13 SUB2009-00005

THISTLEWAITE PLACE SUBDIVISION

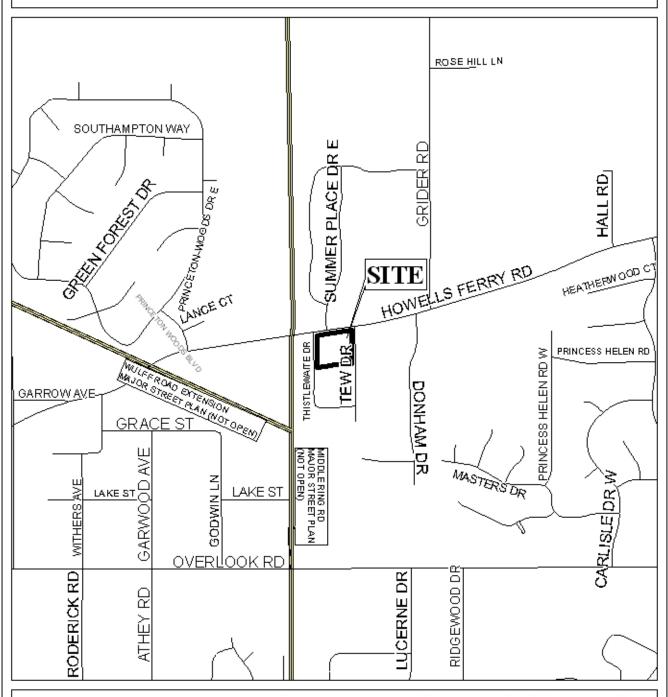
To the North, the site fronts Howells Ferry Road, a minor street with sufficient right-of-way. To the West and East, the site fronts Thistlwaite Drive and Tew Drive, both minor streets (no curb and gutter) with 50' rights-of-way. Section V.B.14. of the Subdivision Regulations requires that minor streets without curb and gutter have a minimum 60' right-of-way; the applicant should revise the plat provide a minimum 30' as measured from the centerline of each street.

Lot 1 has approximately 100' of frontage on Thistlewaite Drive and should be limited to one curb cut; Lot 2 is a corner lot with 200' and 100' of frontage on Thistlewaite Drive and Howells Ferry Road, respectively; Lot 3 has 135' of frontage on Howells Ferry Road; Lot 4 is a corner lot with 100' and 300' on Howells Ferry Road and Tew Drive, respectively. As a means of access management, a note should be place on the final plat stating that each lot is limited to one curb cut (including corner lots), with the size, location, and design to be approved by Traffic Engineering and conform to AASHTO standards. An additional should be placed on the final plat stating Lots 2 and 4 are denied direct access to Howells Ferry Road.

As proposed, the plat does not illustrate adequate radii where Howells Ferry Road intersects both Thistlewaite and Tew Drives. The applicant should revise the plat to comply with Section V.B.16. of the Subdivision Regulations.

- 1) dedication of sufficient right-of-way, for both Thistlewaite and Tew Drives, to provide a minimum 30' as measured from the centerline of each street;
- 2) placement of a note on the final plat stating that each lot is limited to one curb cut, with the size, location, and design to be approved by Traffic Engineering and conform to AASHTO standards;
- 3) placement of a note on the final plat stating that Lots 2 and 4 are denied direct access to Howells Ferry Road;
- 4) provision of adequate radii, in compliance with Section V.B.16. of the Subdivision Regulations, where Howells Ferry Road intersects both Thistlewaite and Tew Drives; and
- 5) placement of a note on the plat / site plan stating that the site must be developed in compliance with all local, state and Federal regulations regarding endangered, threatened or otherwise protected species.
